Inland Rail – Illabo to Stockinbingal

Assessment of Inland Rail & John Holland Group's Environmental System Compliance in accordance with SSI-9406 Conditions of Approval

Audit Reference:	A01535-04
Audit Organisation:	Inland Rail (Proponent) John Holland Group (Contractor)
Auditors:	Sanan Qasim – Lead Auditor Barbara Pater – Alternate Lead Auditor
Date of Audit:	22-24 April 2026
Draft Report Submitted:	5 June 2026
Final Report (V0) Submitted:	19 June 2026
Final Report (V1) Submitted	3 August 2026

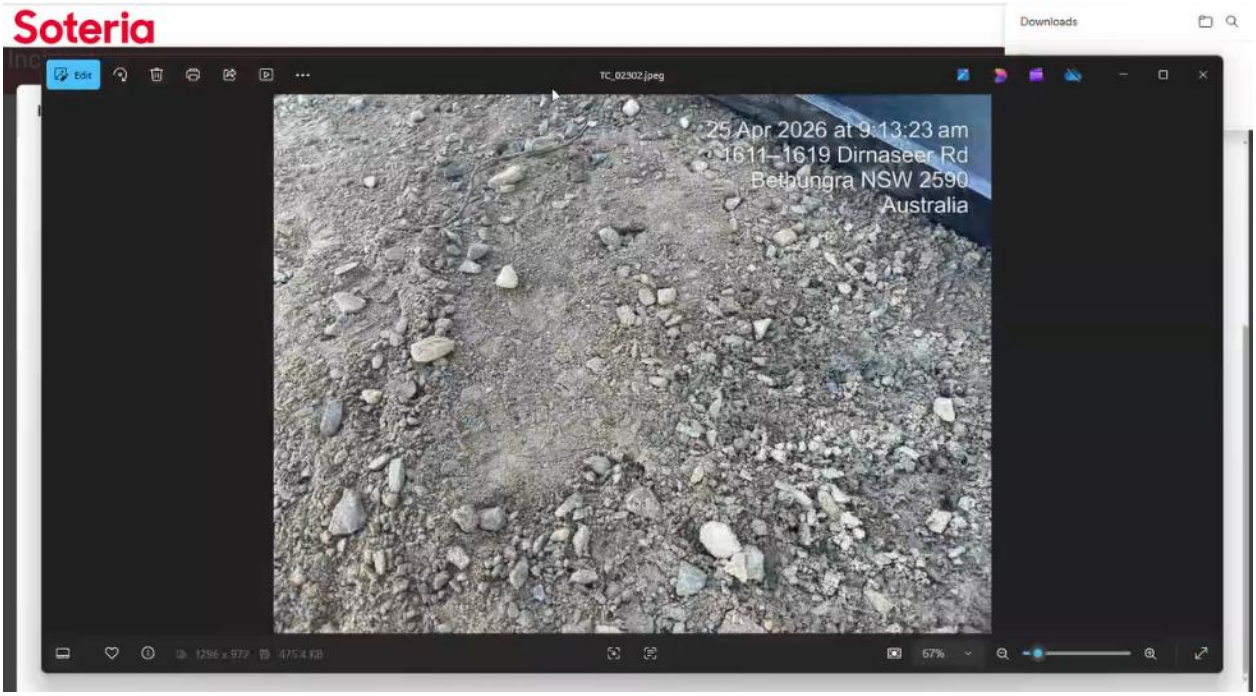
OBS-03: One section of the sediment fence had been removed at the corner of the Gate 7B low sump area. Reinstatement is recommended to ensure adequate controls.
